**MACEDONIA PLANNING COMMISSION
MEETING AGENDA
JULY 18, 2022**

- 2) Mr. Zickafoose is proposing a pickup window, revised parking and dumpster relocation for Chipotle located at 8195 Golden Link Blvd.

- 3) Mr. Lindsley with Kimley-Horn is proposing the installation of electric charging stations at 8100 Macedonia Commons Blvd.

To: Planning Commission
From: Joe Gigliotti, City Engineer
Date: 07-05-22
Re: Planning Commission Review Comments: Chipotle

PROPOSED SITE LAYOUT

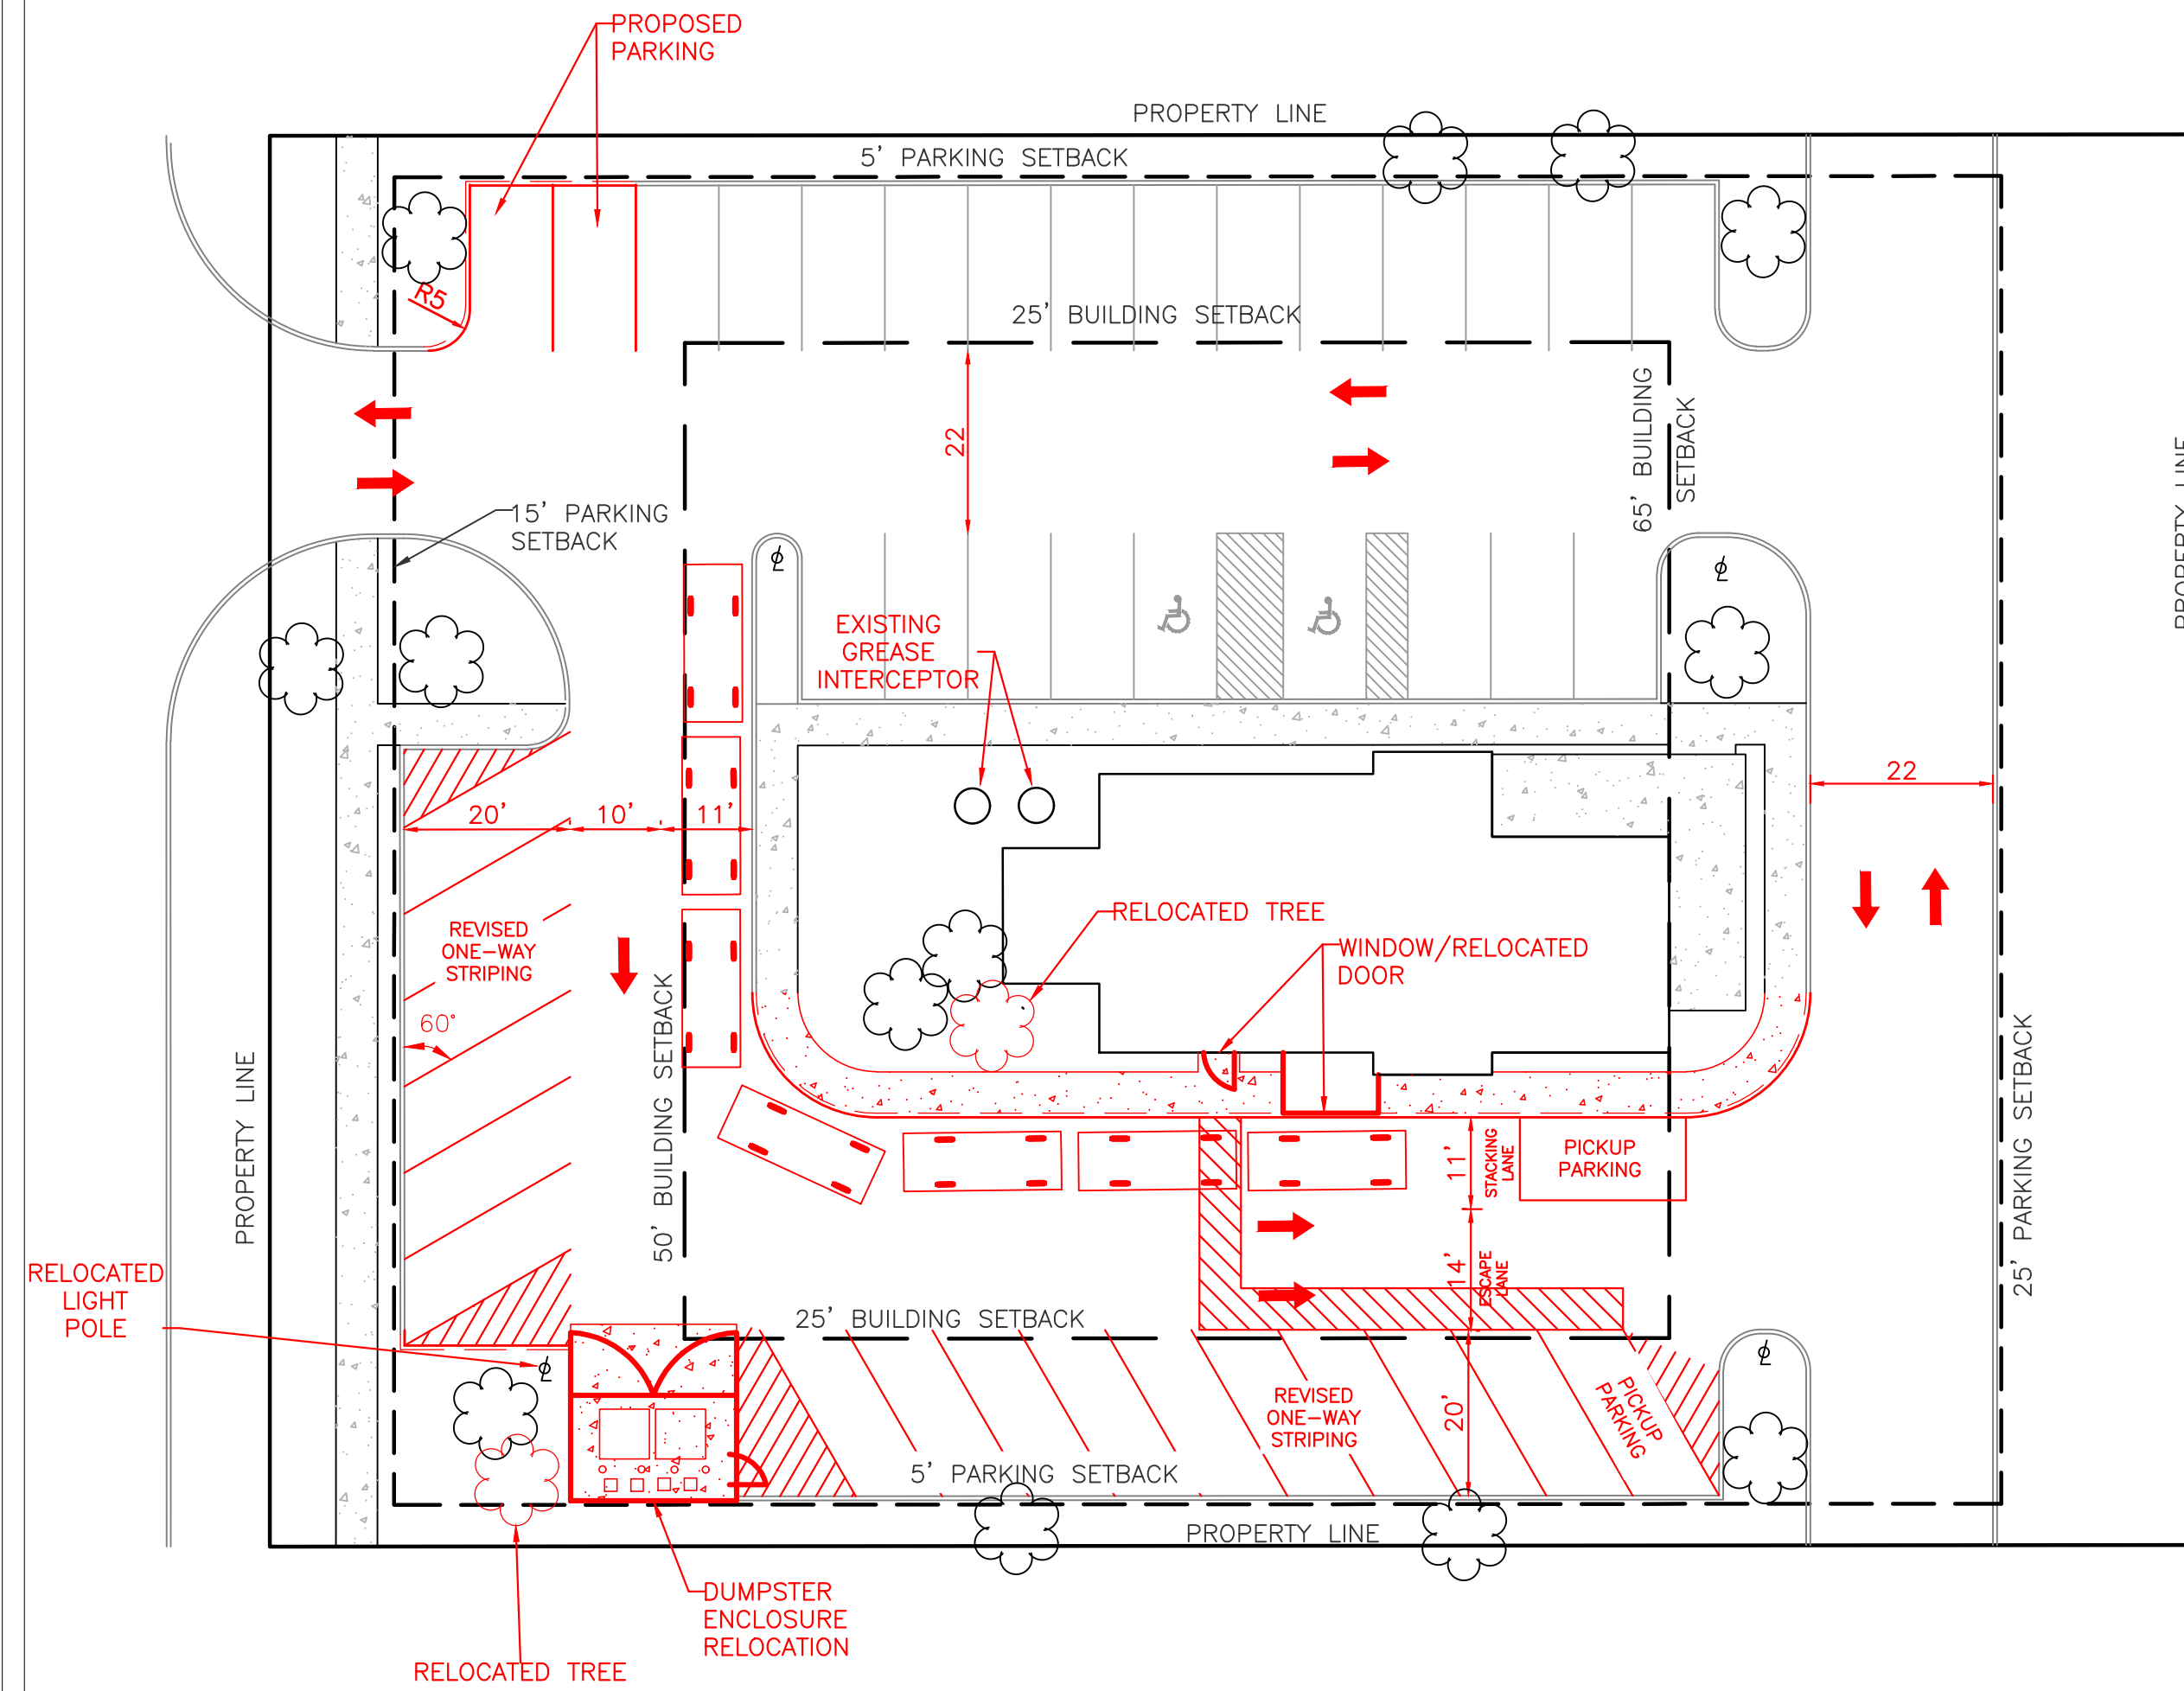
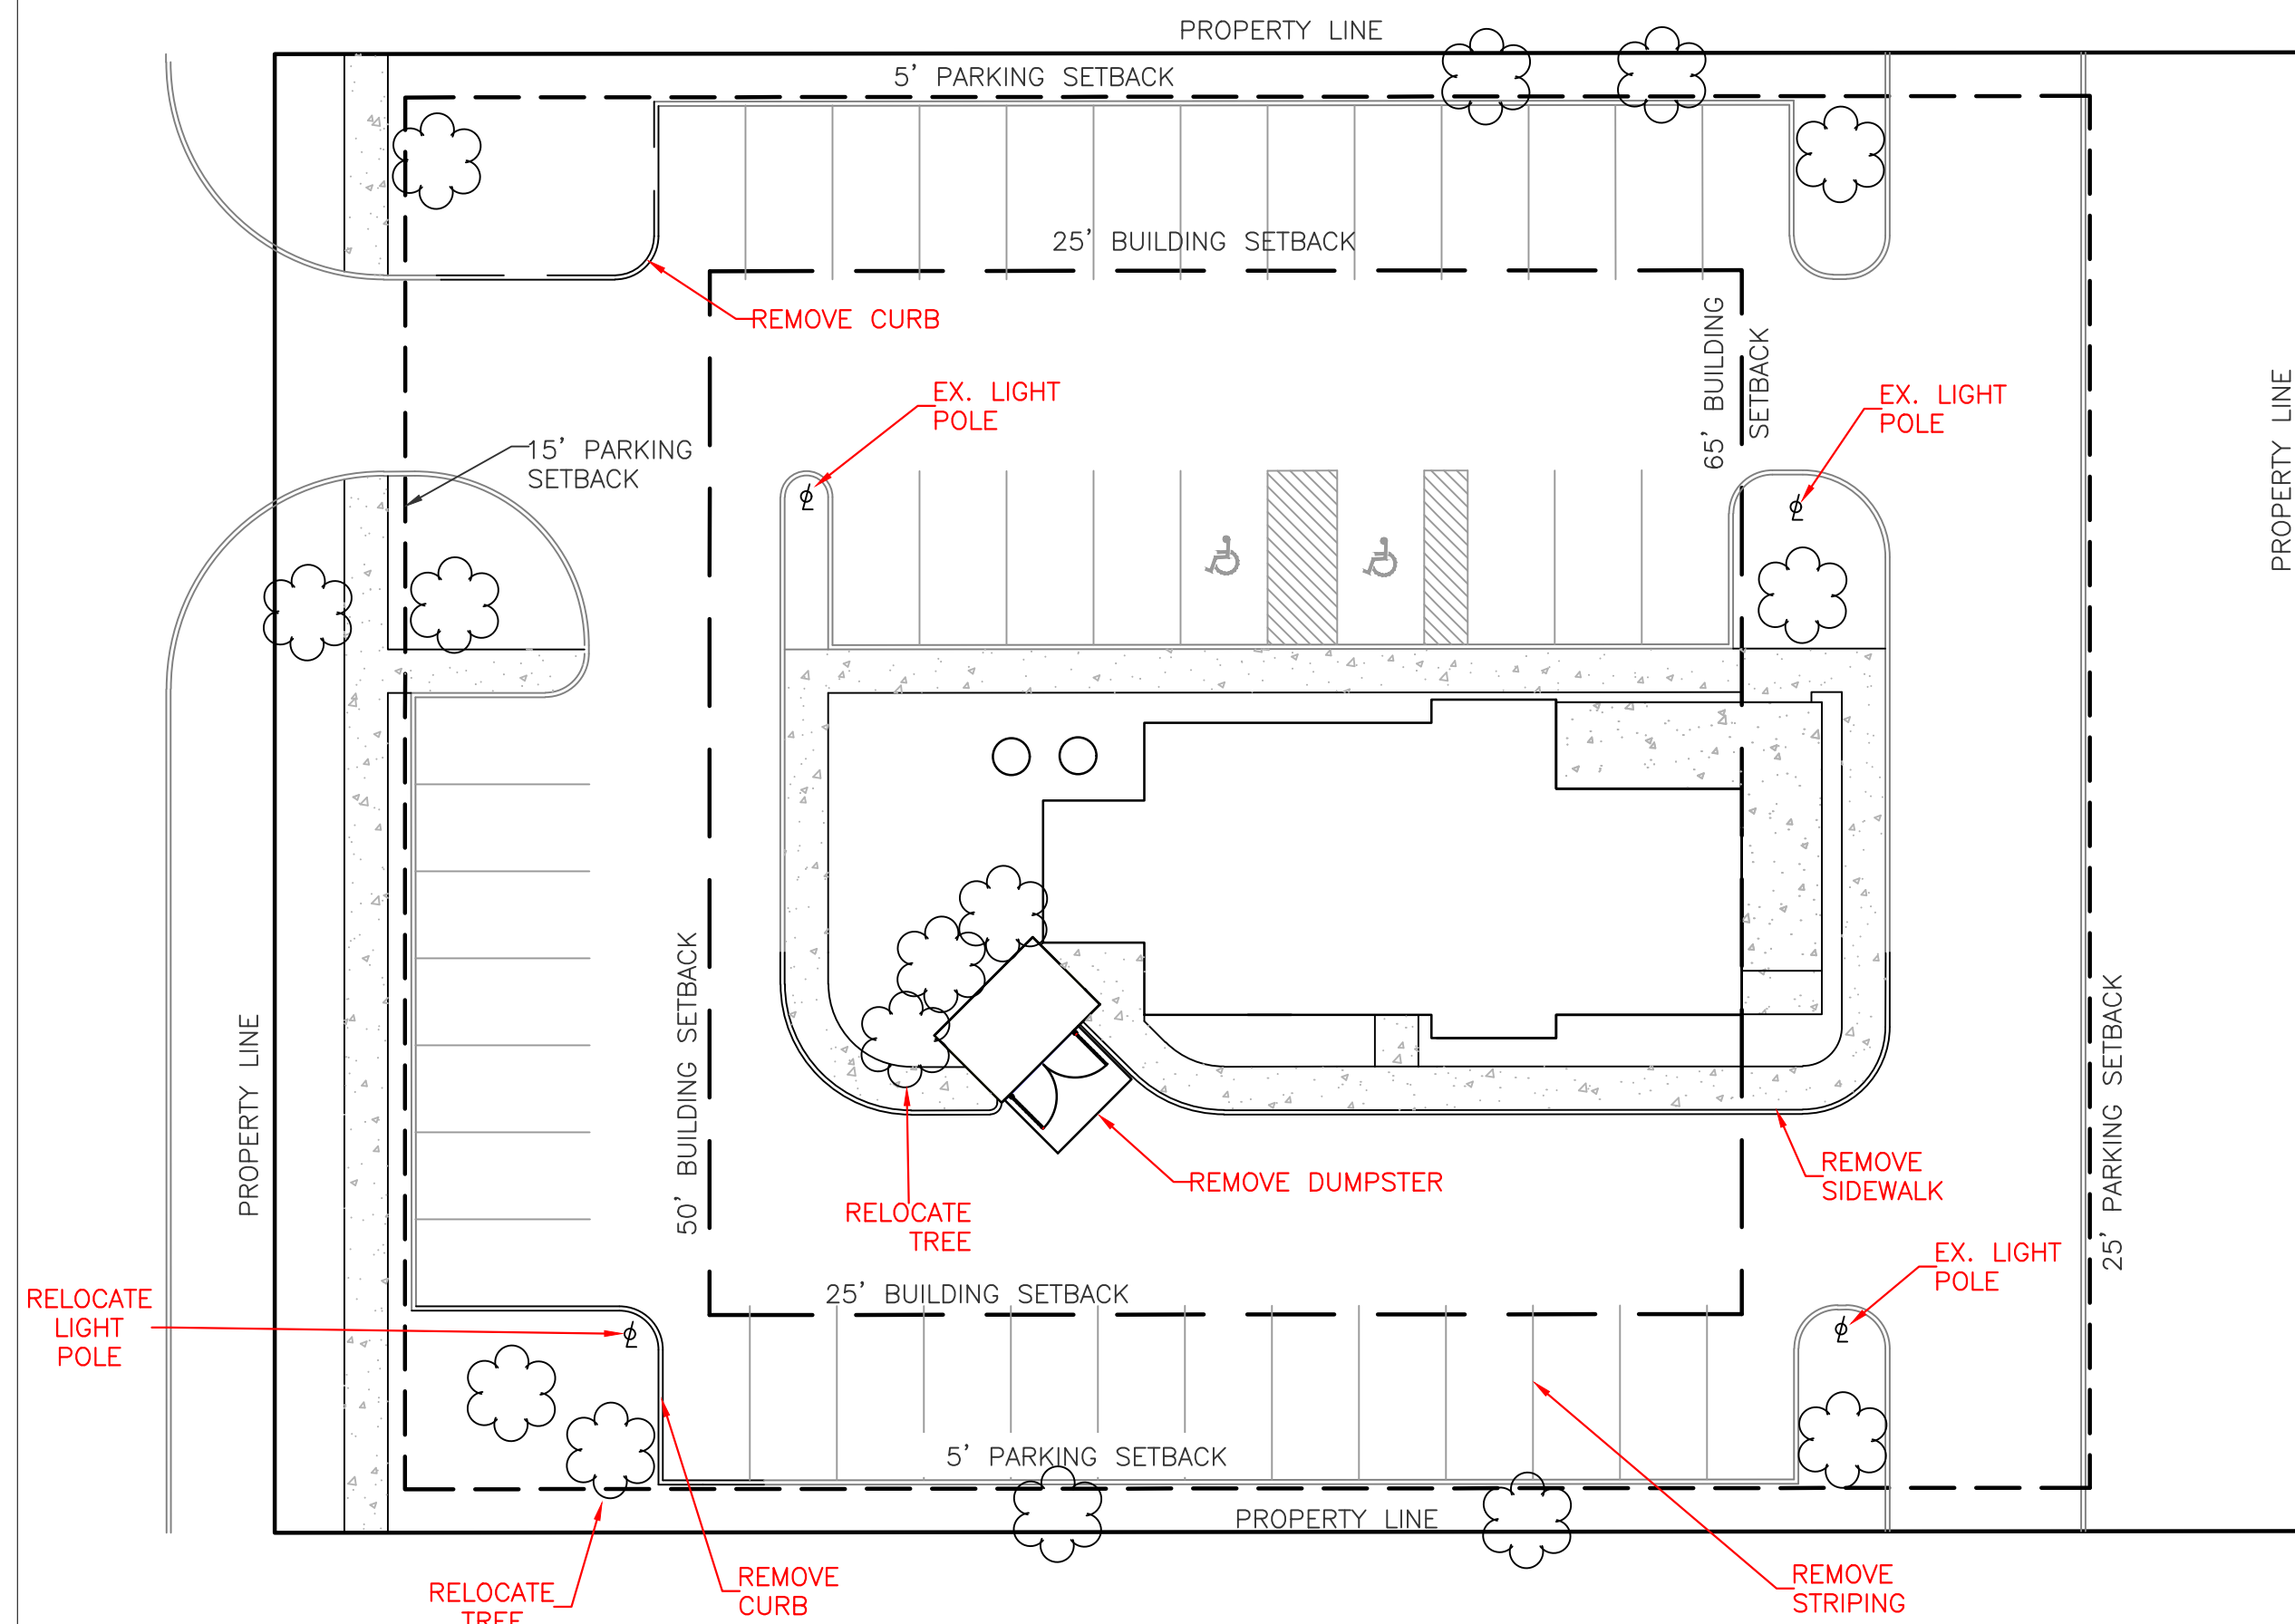
- 2) The traffic adjacent the drive-thru lane (and in the drive-thru lane) will intersect two-way traffic traveling north/south along the east side of the site. This intersection is a “pinch-point” for potential traffic conflicts. To avoid this, appropriate signage must be installed on the site to help avoid accidents. **ACTION ITEM: A stop bar/painting (similar to the Chick-Fil-A and Panera Bread drive-thru markings) should be added at the drive-thru on the east elevation to control the traffic exiting onto the driveway located between the neighboring restaurants.**

- 4) If this plan advances beyond BZA approval, I suggest that the applicant be required to include a black decorative fence (with brick columns and lights) along the Route 8 frontage to match the fencing created along the frontage of neighbor's property to the north and south.
ACTION ITEM: Add the black decorative fence along Route 8 to match the existing neighbors to the north and south.

In general, the proposal over builds the site and is not appropriate given the parcel size. The only method I see to bring this project to fruition is by eliminating the parking along the western and southern side of the site. Variances from the BZA will be needed. I question whether this site should provide drive-thru accommodations given the overall size of the property. The Planning Commission should continue this matter until the applicant secures variances from the BZA.
